U.S. NUCLEAR REGULATORY COMMISSION

STANDARD REVIEW PLAN

2.4.6 PROBABLE MAXIMUM TSUNAMI FLOODING

Figure 2.4.6-1

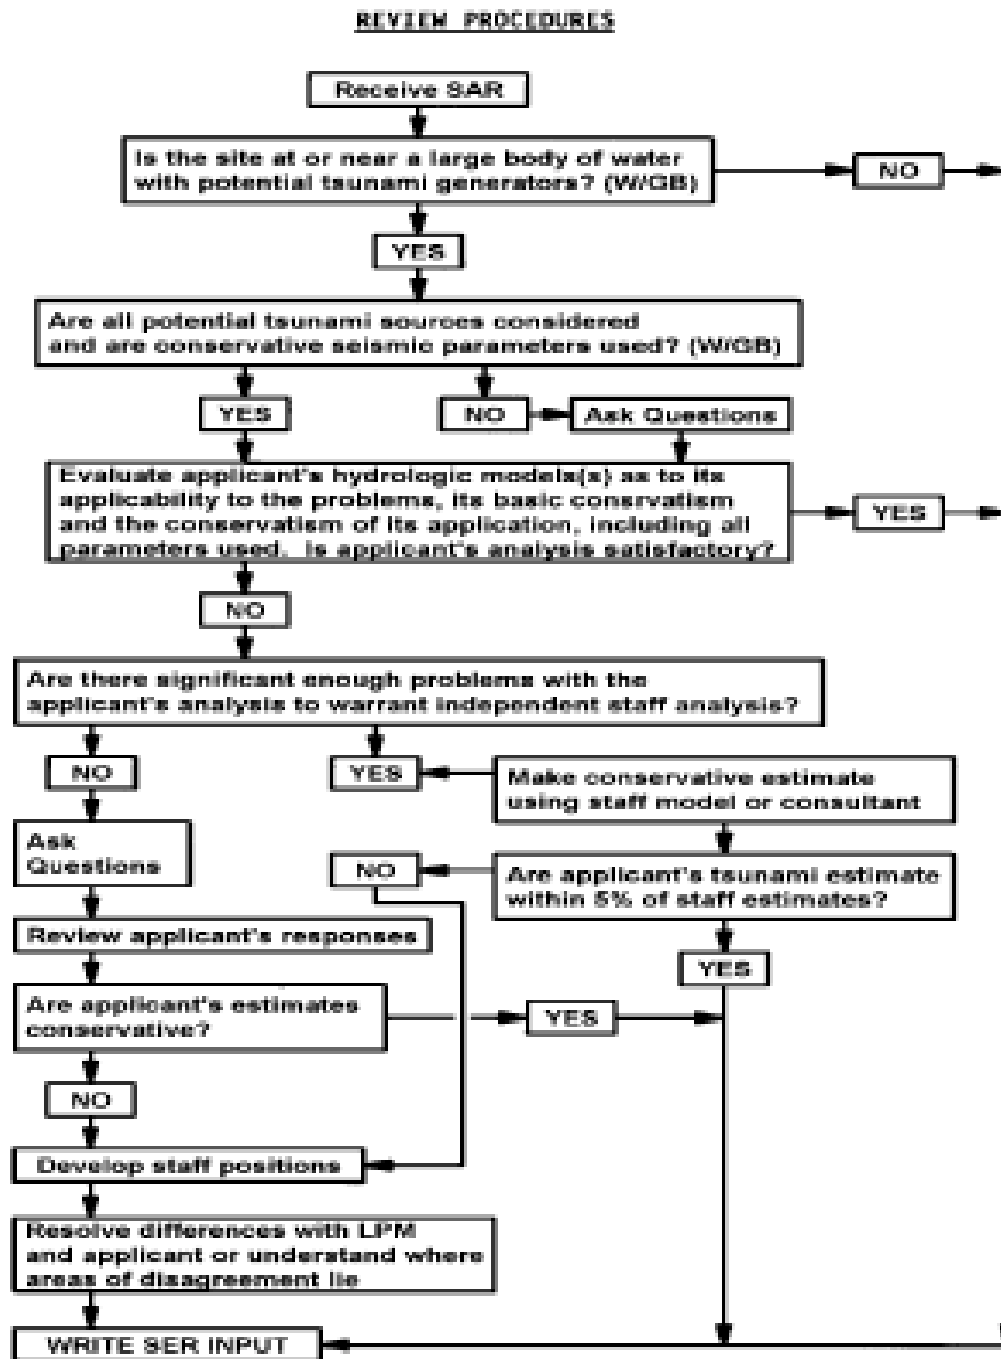
~~The review procedures are outlined in Figure 2.4.6-1. The references used for this review~~ are general geophysical, seismological, and hydrodynamic publications, such as published data by the National Oceanic and Atmospheric Administration (NOAA), and wave propagation models, such as those developed by NOAA, the Corps of Engineers' Waterways Experiment Station (WES), and Tetra Tech.

FIGURE DELETED
